## Development Review Division

Community Development Department: Town Hall / 20120 East Mainstreet Parker, CO 80138 Phone: 303.841.2332 Fax: 303.841.3223

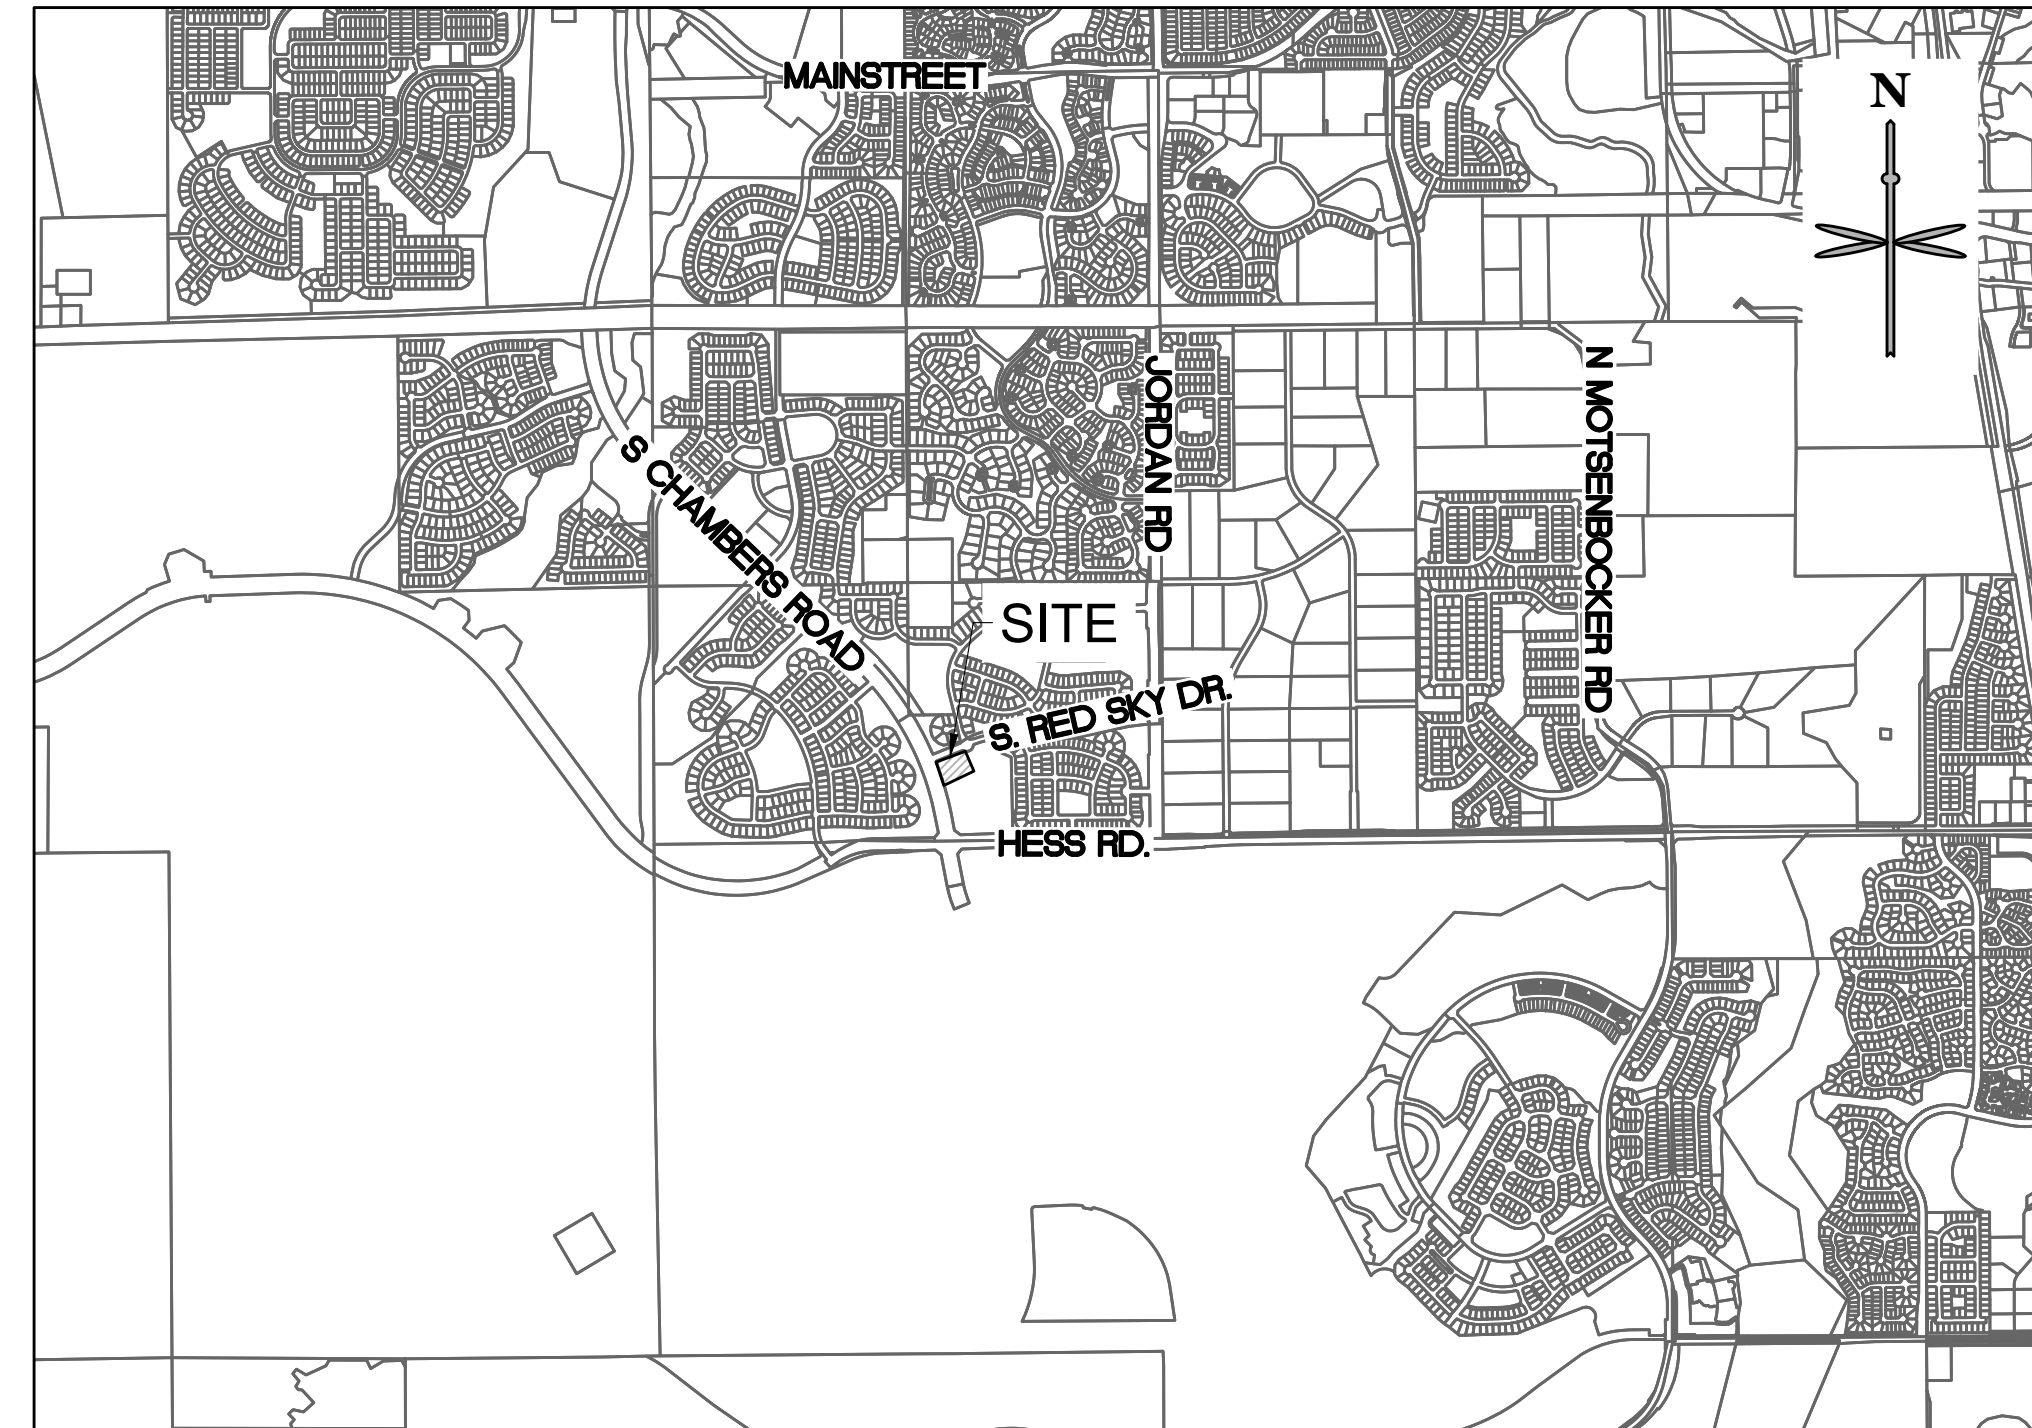
## TOWN OF PARKER PLAN REVIEW
